**KNOXVILLE/KNOX COUNTY METROPOLITAN PLANNING COMMISSION  
SUBDIVISION REPORT - CONCEPT/USE ON REVIEW**

▶ **FILE #:** 5-SM-07-C **AGENDA ITEM #:** 12  
 5-B-07-UR **AGENDA DATE:** 12/13/2007

▶ **SUBDIVISION:** WILLOW CREEK  
 ▶ **APPLICANT/DEVELOPER:** GRAHAM CORPORATION  
 OWNER(S): Graham Corporation

▶ **PROPOSED USE:** Commercial subdivision / shopping center

<b>W. LOW FORK</b> <b>S. DIVISION</b>		<b>11-21-07</b>												
<b>G. AHAM CORPORATION</b> <b>T. 01 MERCHANTS DR</b> <b>K. OXVILLE, TN 37912</b> <b>K. OX. COUNTY,</b> <b>TN TENNESSEE</b>		<b>CONCEPT SUBDIVISION</b> <b>PLAN</b> <b>FOR</b> <b>WILLOW FORK</b> <b>SUBDIVISION</b>

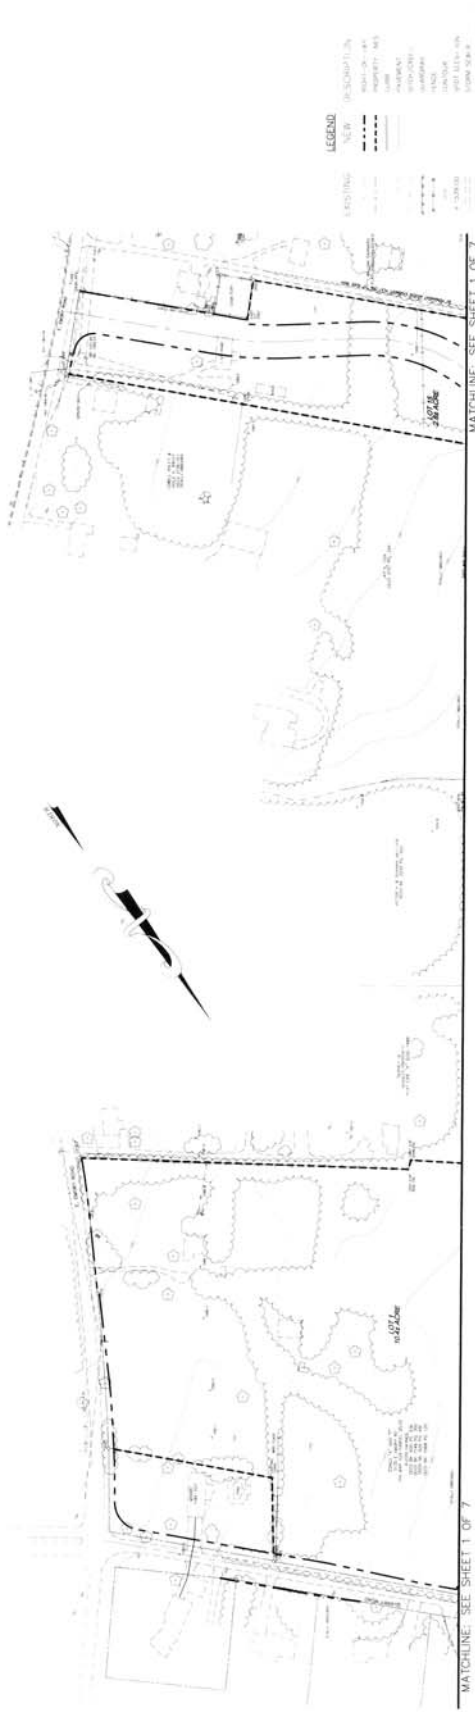
▶ **SUBDIVISION VARIANCES REQUIRED:** 1. Vertical curve variance from 318.25' to 191' at sta 30+30 of Quarry Rd.

▶ **DENY variance 1 because the sight distance at the existing driveways would be negatively impacted**

1. Connection to sanitary sewer and meeting any other relevant requirements of the Knox County Health Department.
2. Provision of a street name which is consistent with the Uniform Street Naming and Addressing System within Knox County (91-1-102)
3. Meeting all applicable requirements of the Knox County Dept. of Engineering and Public Works
4. The proposed driveway to lot 9 from the main access to Maynardville Hwy. being constructed to permit right

turn in and out only

5. As part of the design plan provide road cross sections for Quarry Rd. and the new connector Rd. All grading for these roads must be done within property controlled by applicant or Knox County. Driveway access to the adjoining properties and sight distance at each these driveways must be maintained

6. All road and access/traffic circulation improvements called for in the traffic impact study must be implemented on a schedule to be determined by the Knox County Dept. of Engineering and Public Works and the Tenn. Dept. of Transportation (TDOT) as part of the design plan review (see attached)
